Serial No.: 10/791,958

Amendments to the Drawings

Remarks/Arguments

Fig. 6

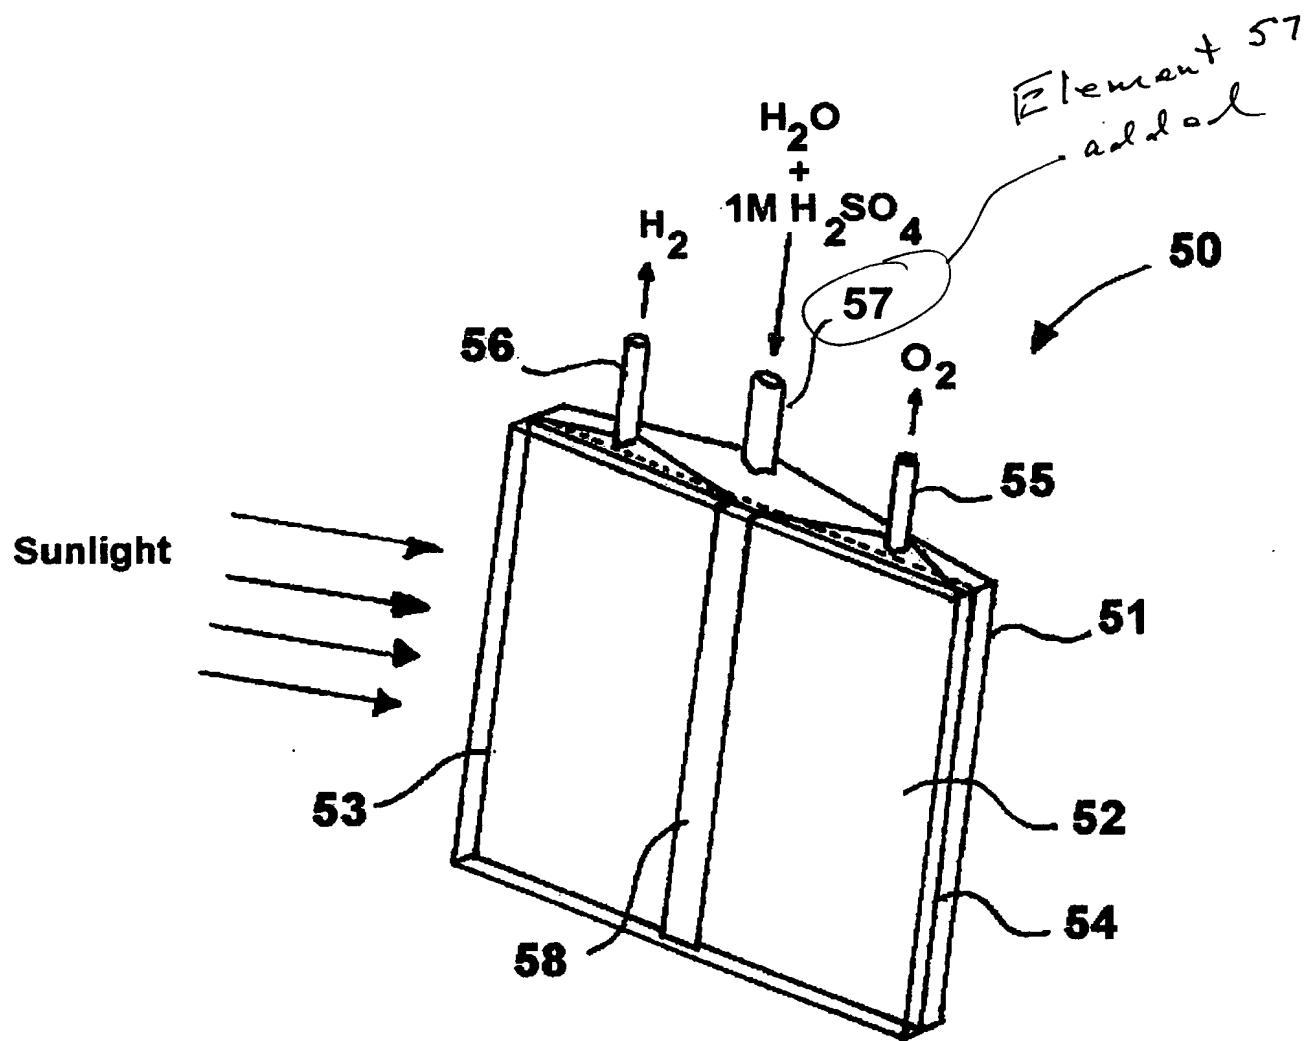
The drawings have been objected to as failing to comply with 37 CFR 1.84(p)(5) because they do not include reference numeral 57 in Fig. 6 as mentioned in the description. In response to this objection, Applicants have amended Fig. 6 by

The attached sheet of drawings includes changes to Fig. 6. This sheet replaces the original sheet including Fig. 6. In Fig. 6, previously omitted element 57 has been added.

adding the missing reference numeral. Both a replacement sheet and an annotated sheet are enclosed with this response. Applicants respectfully urge that the amended Fig. 6 overcomes this objection to the drawings.
